PROPOSED CONDITIONS DUNKIN' DONUTS STORE
 445 ROBINSON AVE.
 NEWBURGH, NY
 P.C.# 355621

**Re: Response to Comments Summary
Proposed Dunkin Donuts
445 Robinson Avenue
City of Newburgh, New York**

On behalf of our client, Shiv Management, we are pleased to submit this response to comments summary to the City of Newburgh Department of Planning and Development for the above referenced project. This summary is in response to the various comments received in your letter dated August 2, 2016 and revisited on September 20, 2016, as noted below with our responses in italics. As part of this response to comments summary, enclosed please find one (1) stamped copy of the plan entitled "Site Plan", dated 07/14/2016, last revised 11/02/2016, consisting of one (1) sheets, as well as the architectural plans entitled "Dunkin Donuts Store" dated 11/03/2016, consisting of A1, A2 and A3, provided by Frank Truilo Architect, LLC.

PROPOSED CONDITIONS EXTERIOR ELEVATION

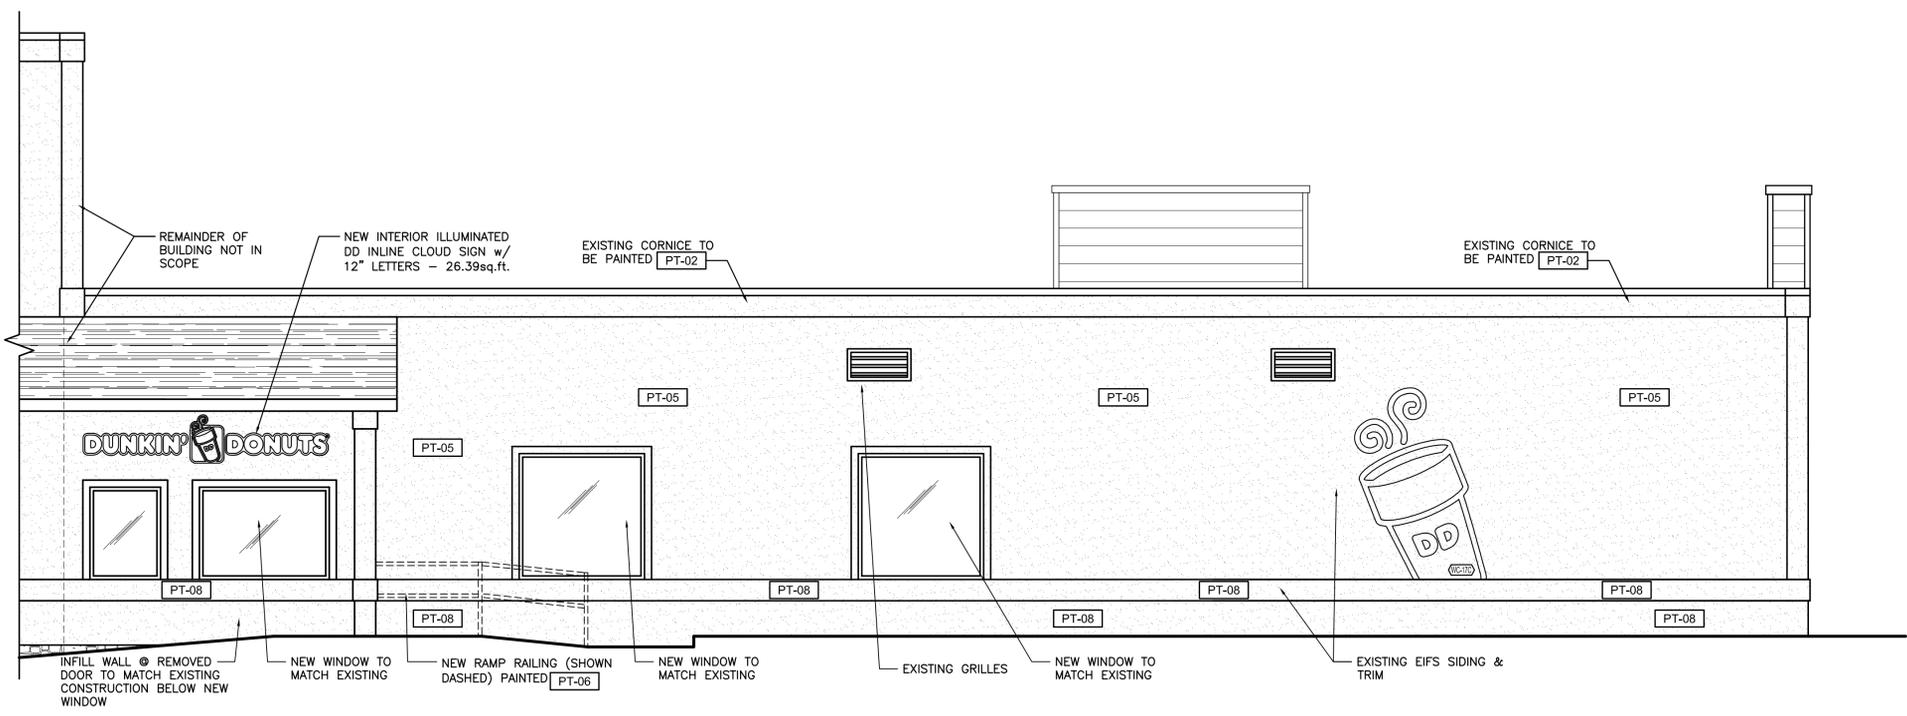
Comment acknowledged; it is common for queuing to occur within a site. A traffic study is pending.
6. Comment Outstanding: CNB, August 2, 2016-The rear entrance to the building shown on the site plan does not correlate with the rear entrance to the building shown on the partial floor plan drawings. Please review the drawings and revise them to match.

Comment acknowledged; the building elevations have been modified to correlate with the improvements to the building.
7. Comment Outstanding: CNB, August 2, 2016- The crosswalk and ADA compliant warning strip provided should be moved to the south in order to provide a flat landing area between the ramp to the entrance and the ramp required to the parking lot.
